Riverside Park Parking Lot Renovations

16-012

RE: Addendum No. 1

Addendum No. 1 dated July 22, 2015 for Riverside Park Parking Lot Redesign

EXISTING CONDITIONS & DEMOLITION PLAN Sheet 2

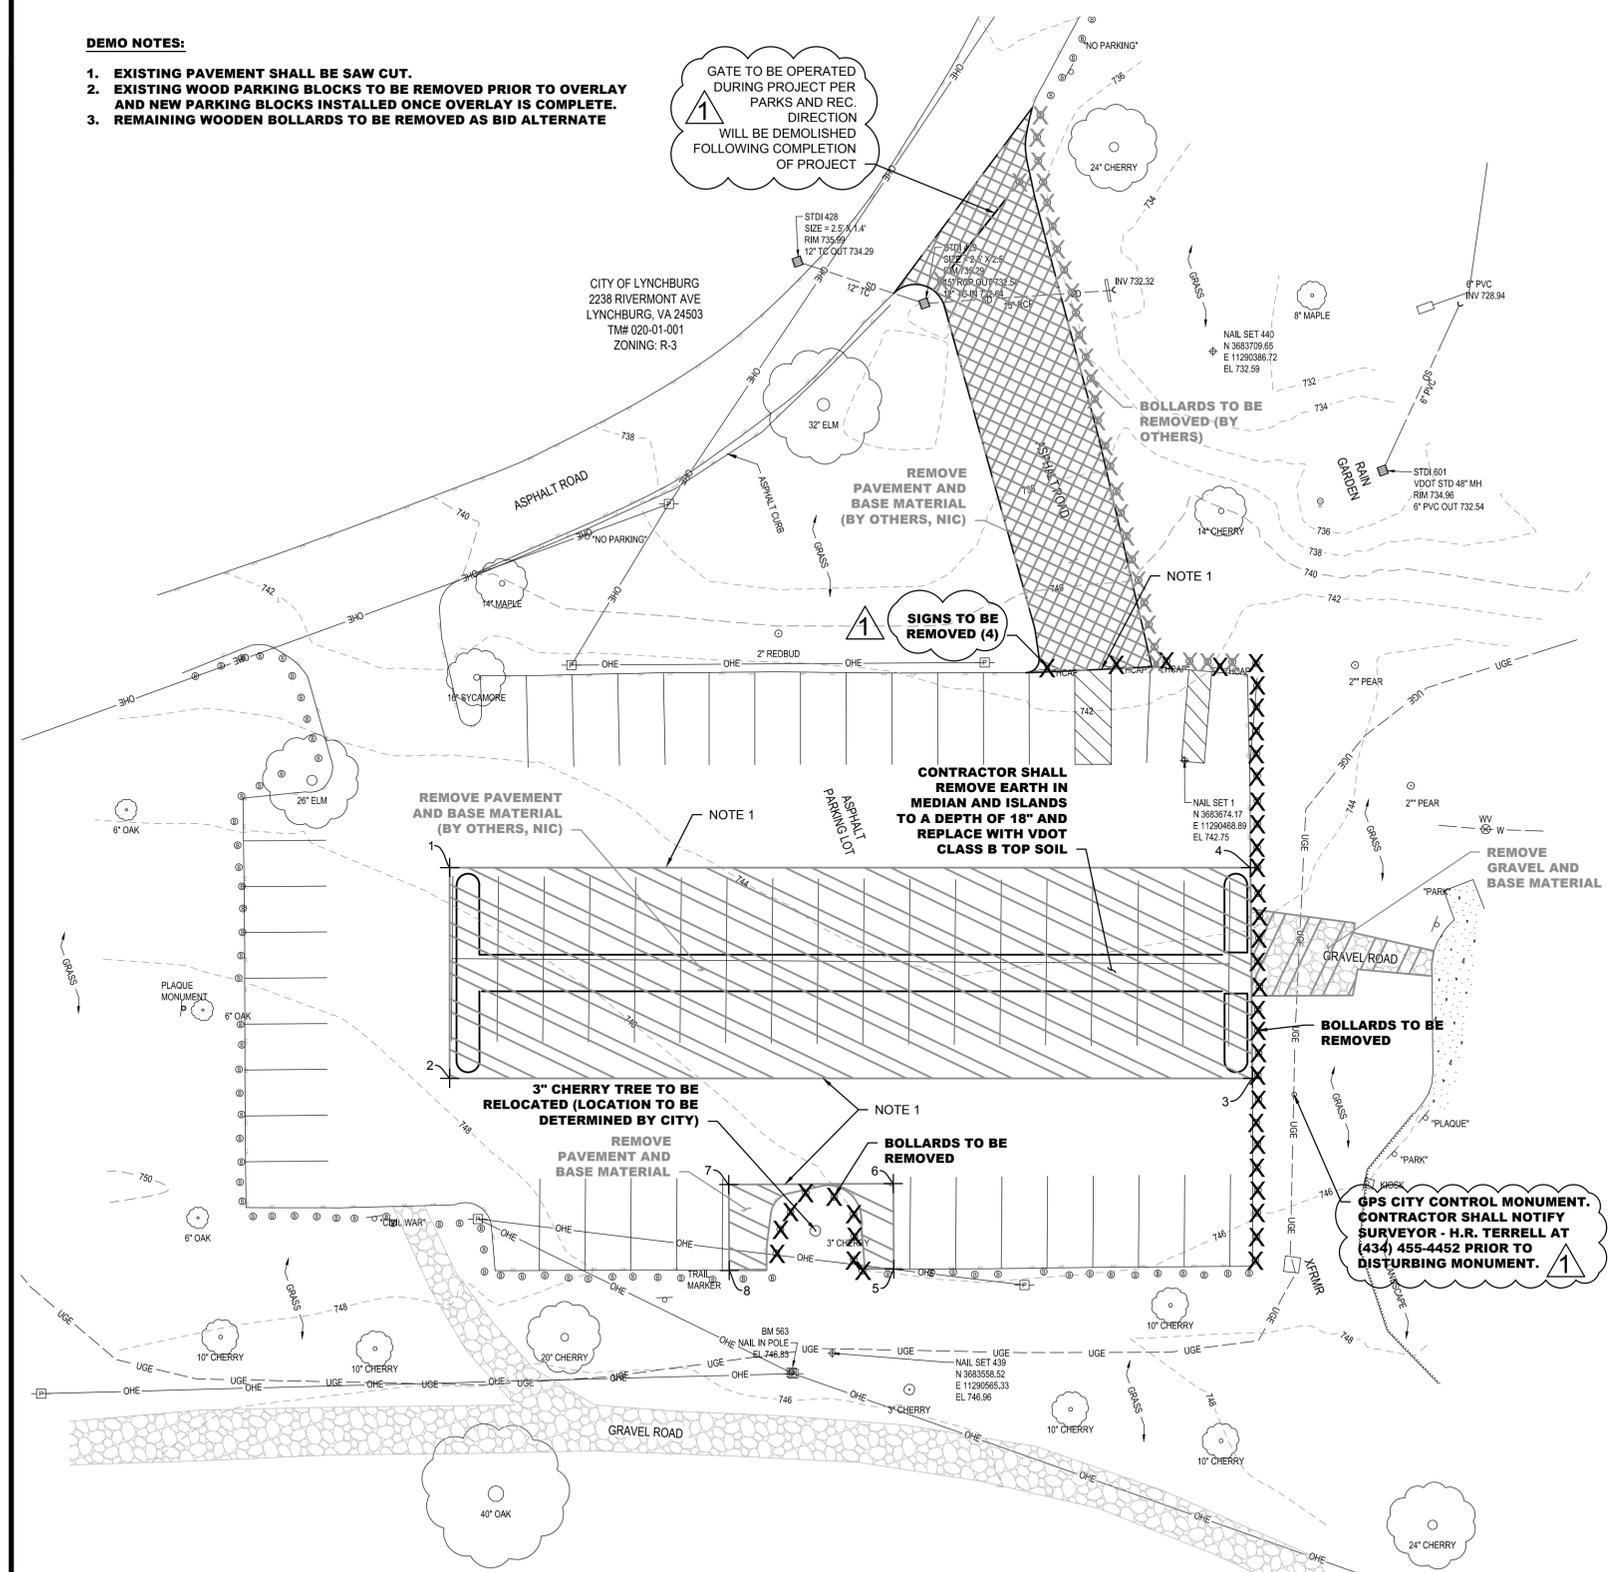
2. Sheet 2: Note revised to read, "Signs to be removed (4)"
3. Sheet 2: Note revised to read, "Gate to be operated during project per Parks and Rec direction. Will be demolished following completion of project."

4. Sheet 2: Under "Demolition" legend/key, label revised to read "Demo by others following project completion"
5. Sheet 2: City control monument shown on drawing

EROSION & SEDIMENT CONTROL PLAN Sheet 3

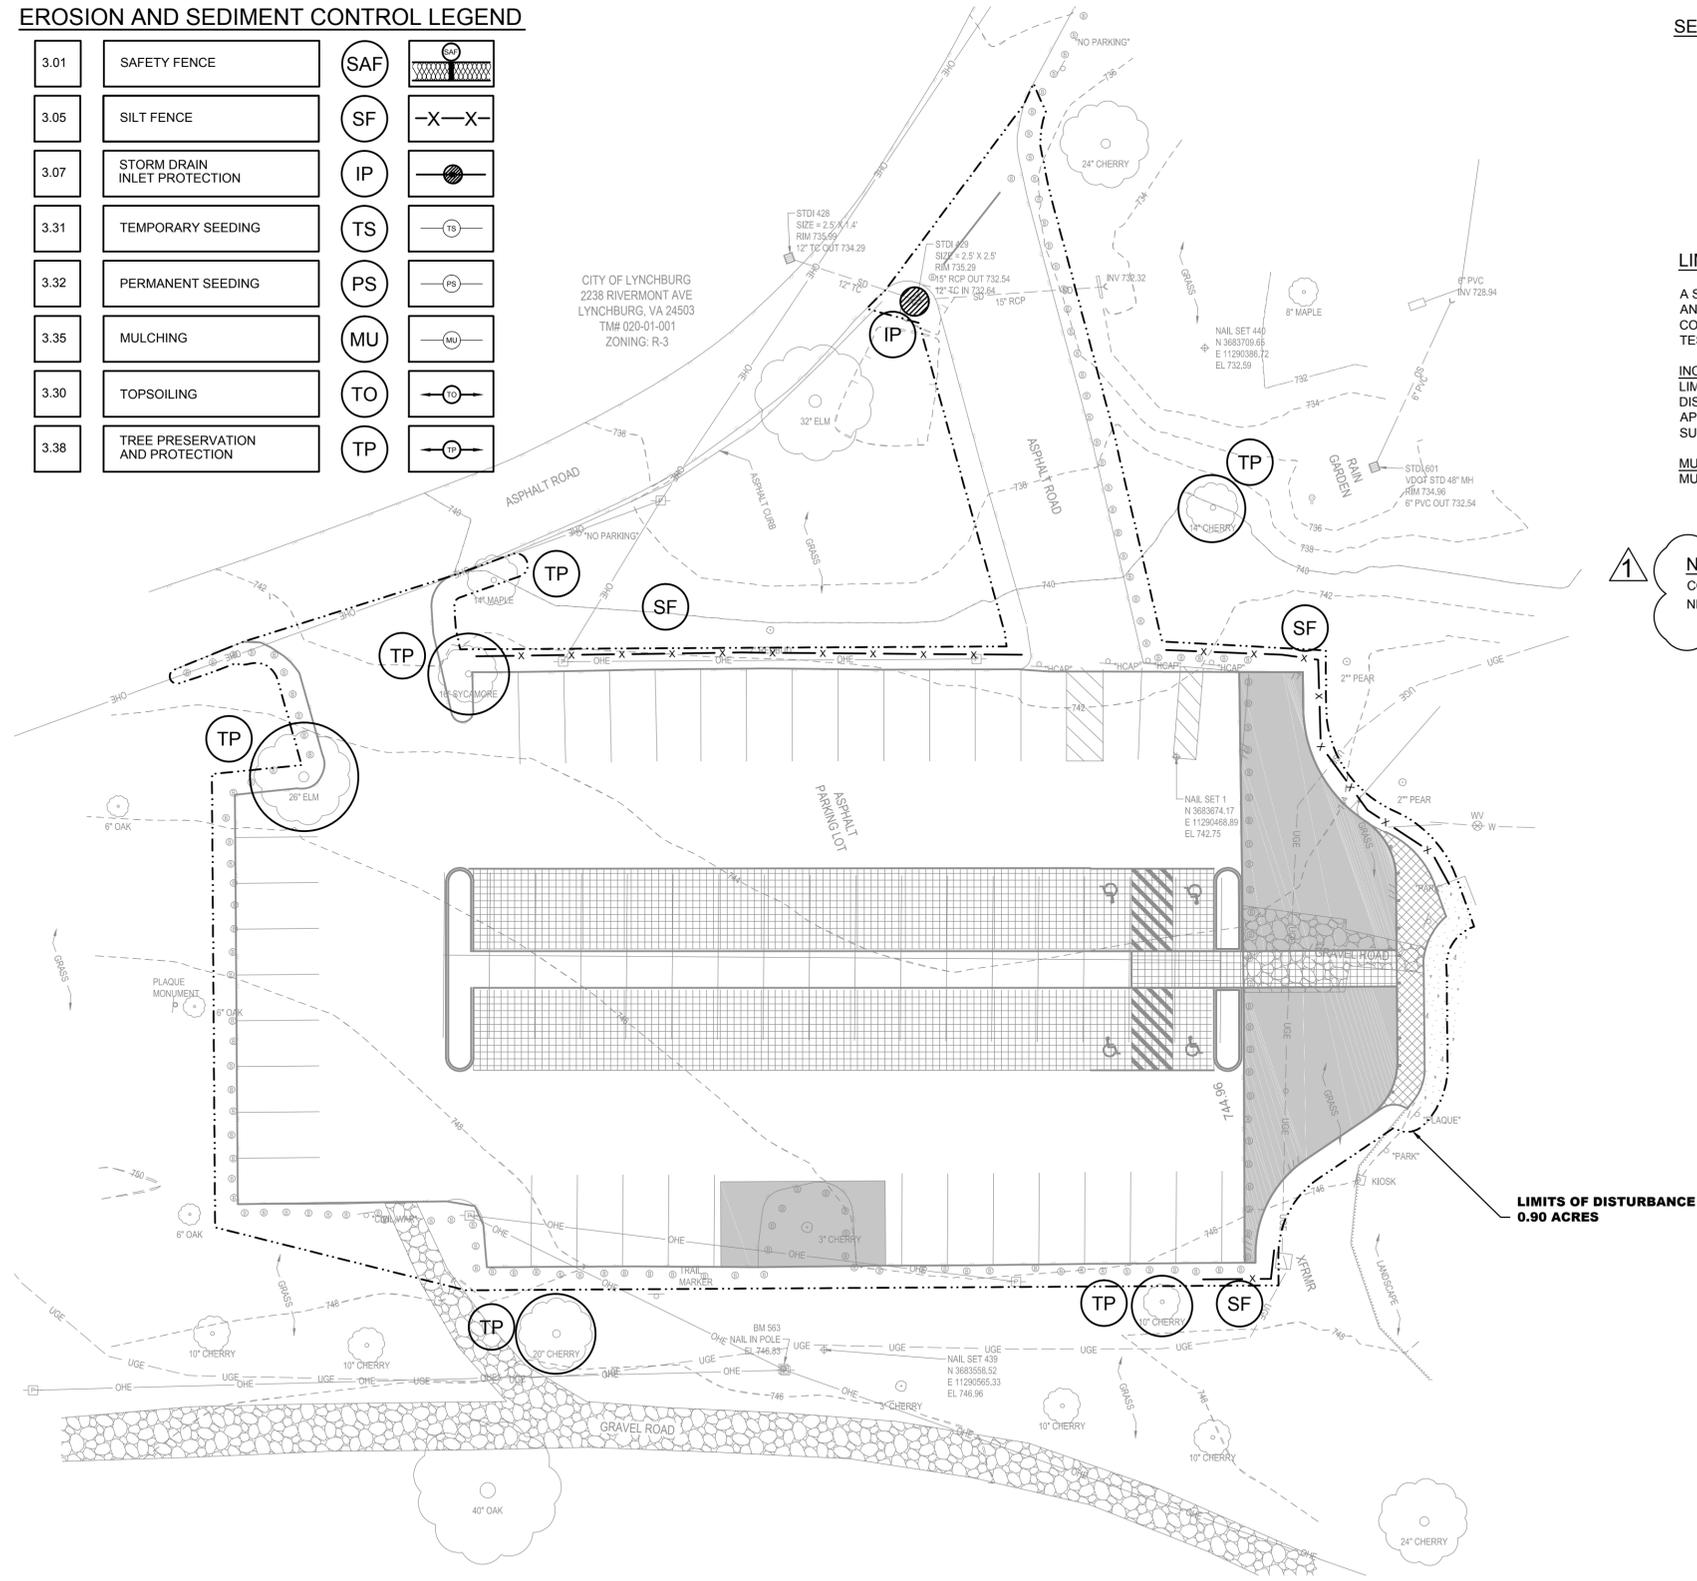
6. Sheet 3: "Note:" revised to read, "Contractor to maintain and/or augment safety fencing as needed to keep pedestrians out of work area."
7. Sheet 4: "Bollards (10)" callout removed

GRADING, SITE IMPROVEMENTS & DIMENSIONAL LAYOUT
 Sheet 4
 Riverside Park Parking Lot Renovations
 Lynchburg, VA

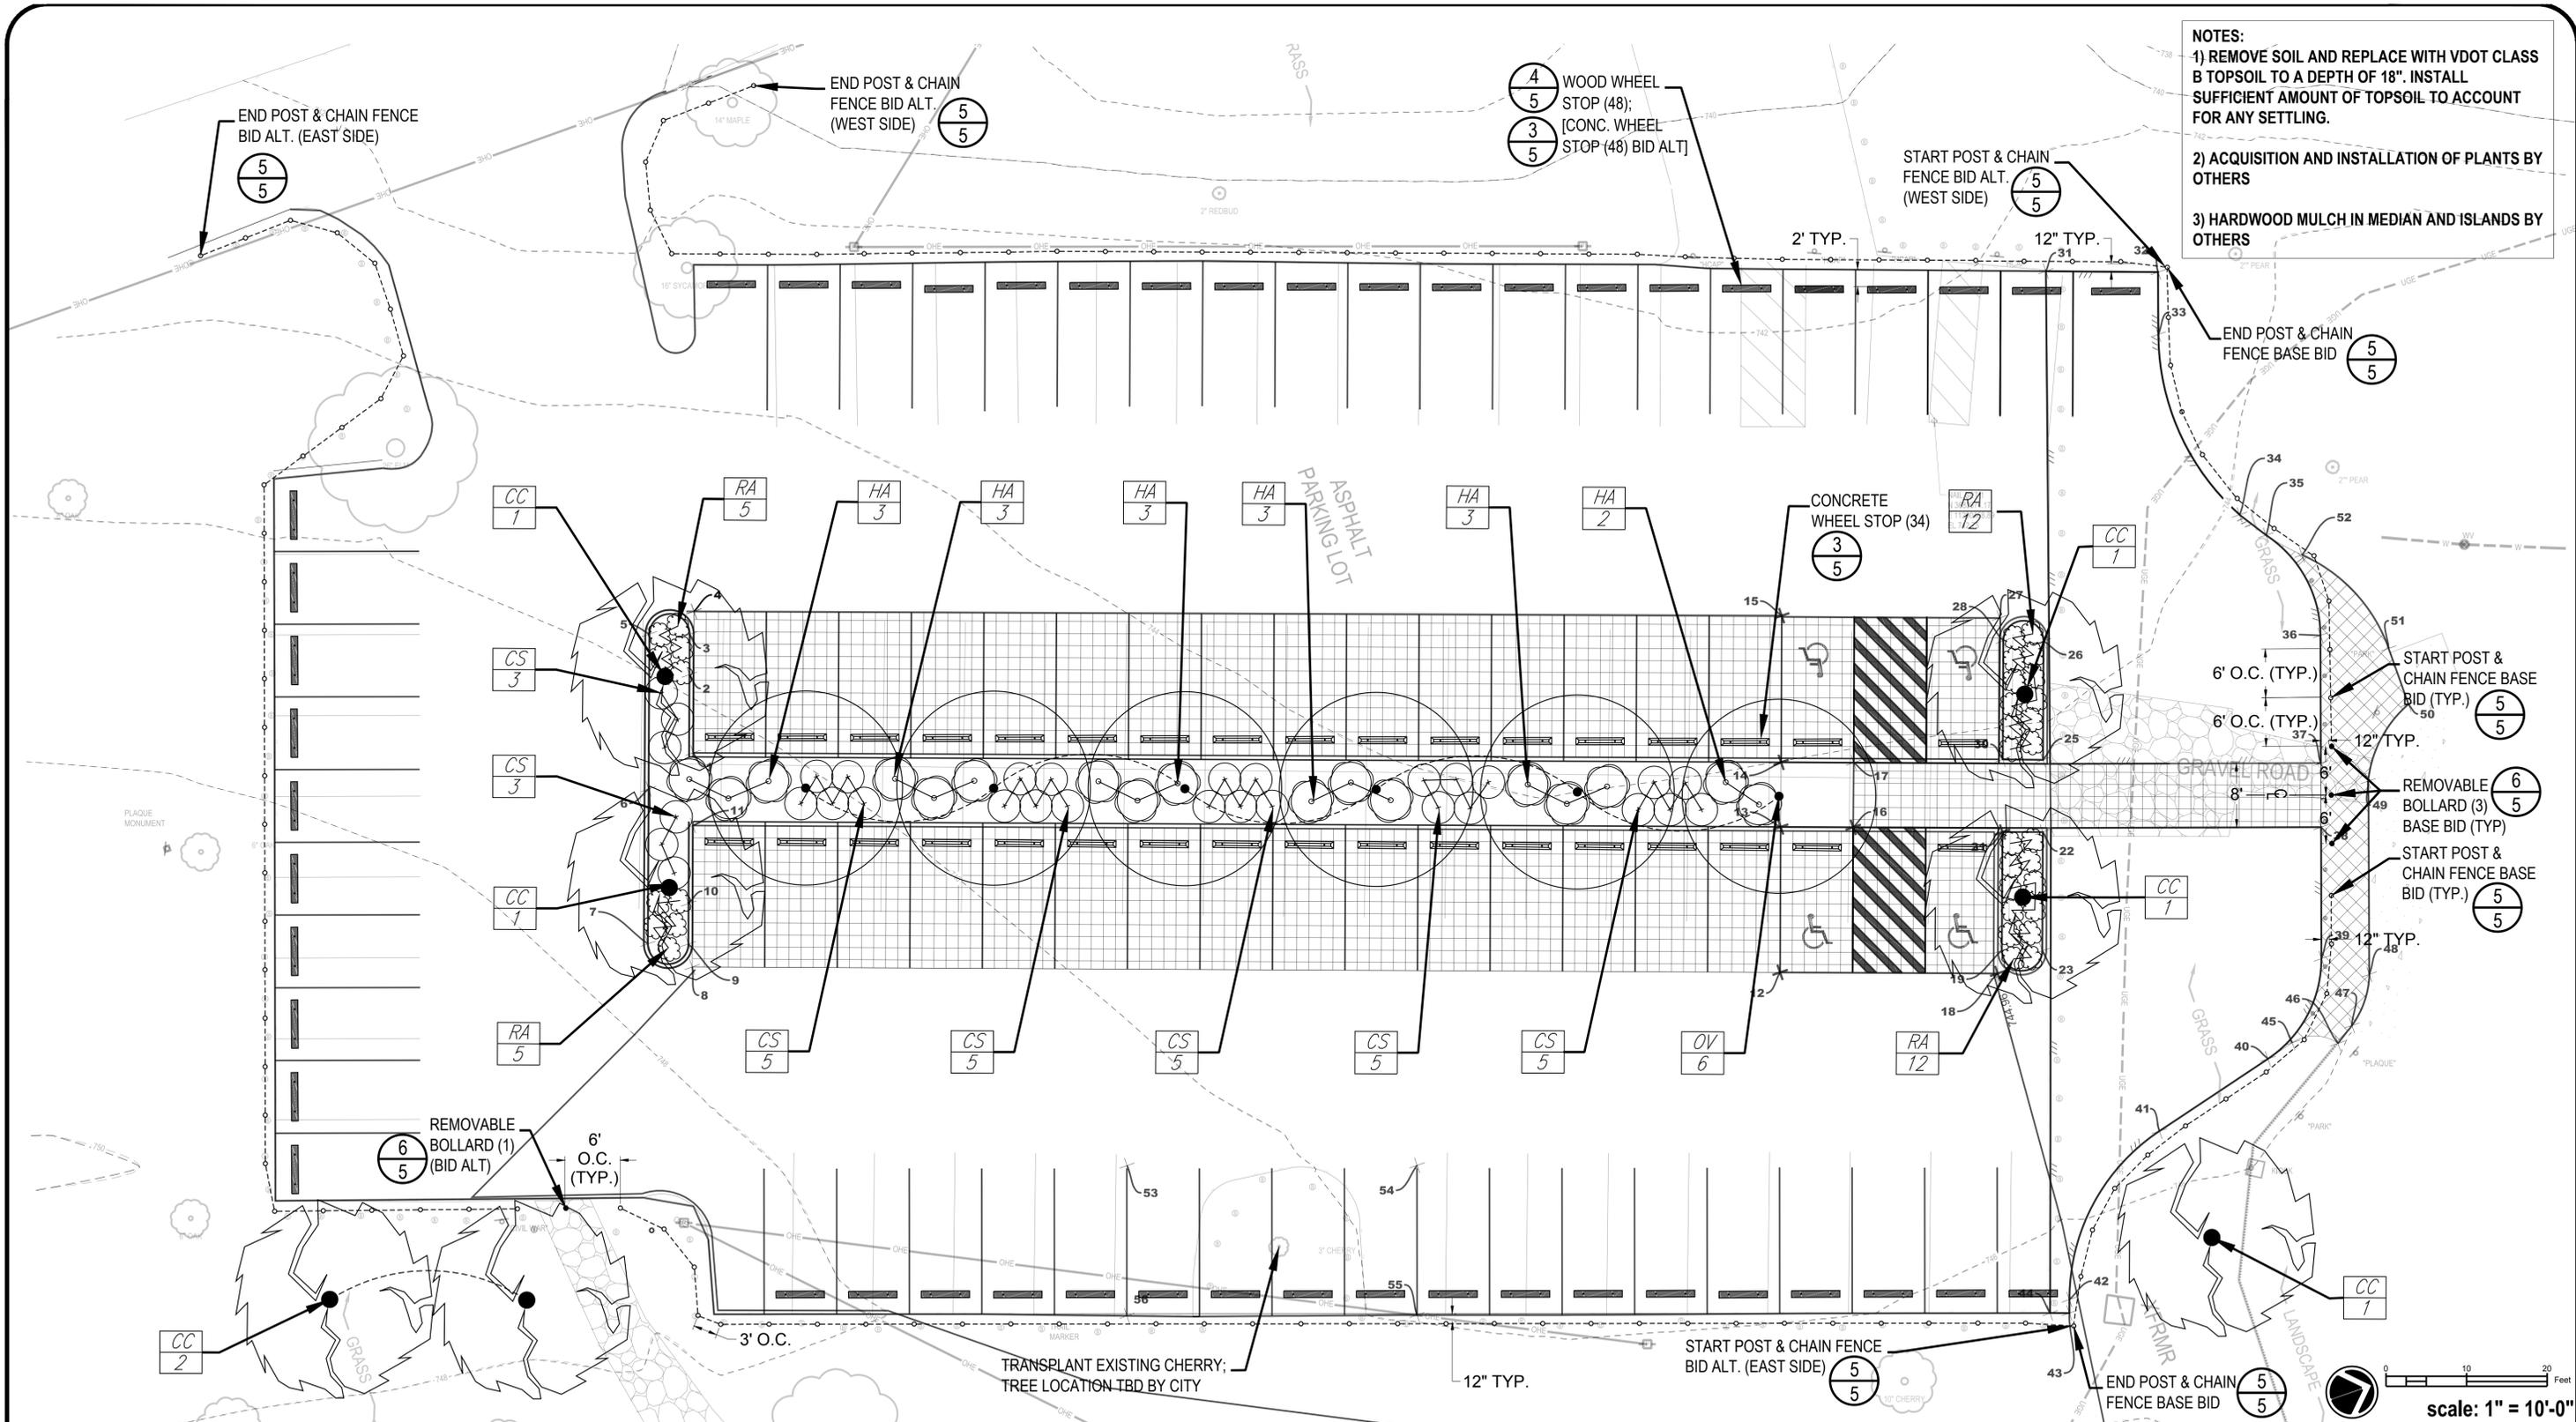
8. Sheet 4: Callout detail 7 on sheet 6 included with callout "permeable pavers"
9. Sheet 4: Site Notes, 1, revised to read, "6-inch concrete curb to be installed..."

10. Sheet 4: Site Notes, 2, revised to include "See detail 5 on page 6."
11. Sheet 4: Site Notes, 4, spelling corrected "aisle"

Site Improvements Details
Riverside Park Parking Lot Renovations
Lynchburg, VA
Sheet 6

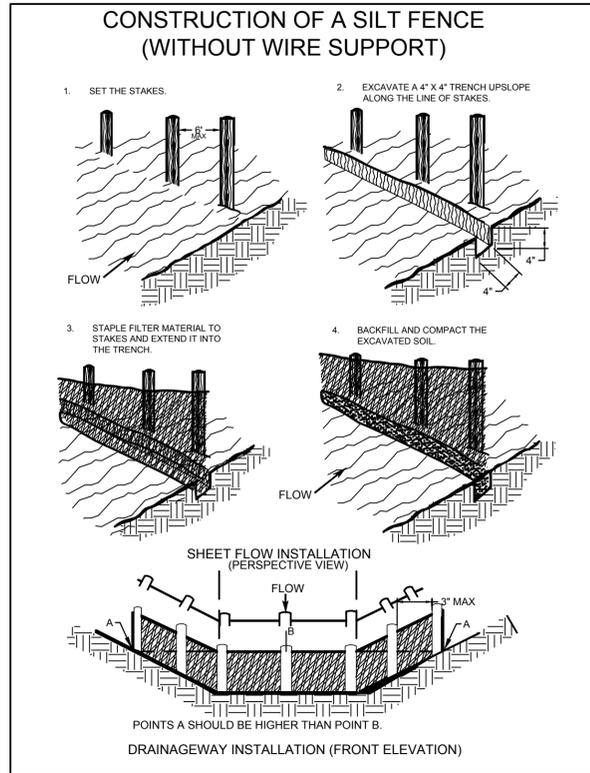
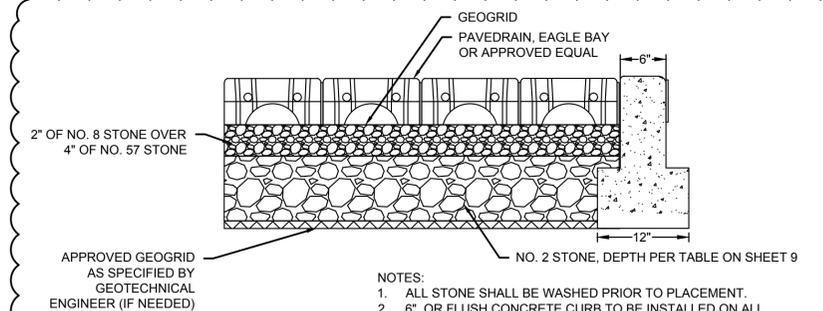
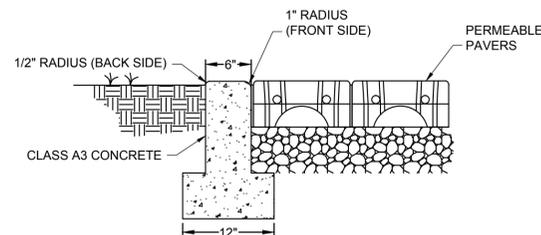
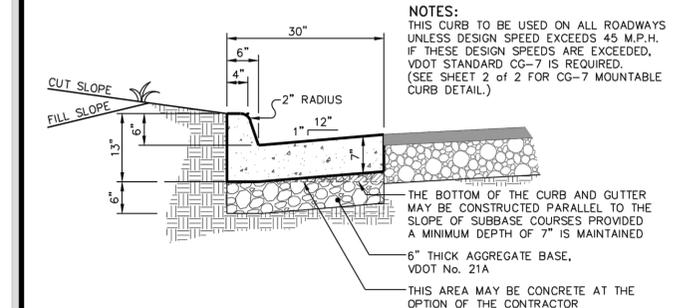
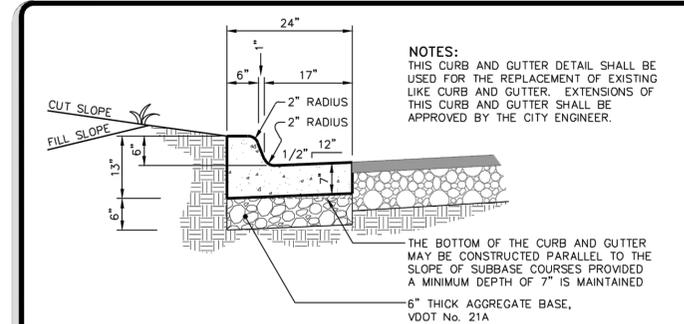
12. Sheet 6: Page number corrected in all numbered details
13. Sheet 6: Note provided to match existing pavers.
14. Sheet 8: Sheet title revised to read "Landscape and Site Furnishing Details"
15. Sheet 10: Erosion & Sediment Control Narrative, II. Existing Site Conditions, sentence revised to read, "The site consists of a mix of asphalt, gravel, and grassy open space."
16. Sheet 10: Erosion & Sediment Control Narrative, VII. Erosion and Sediment Control Measures, A., 2, deleted
17. Sheet 10: Erosion & Sediment Control Narrative, VII. Erosion and Sediment Control Measures, D., 4, deleted
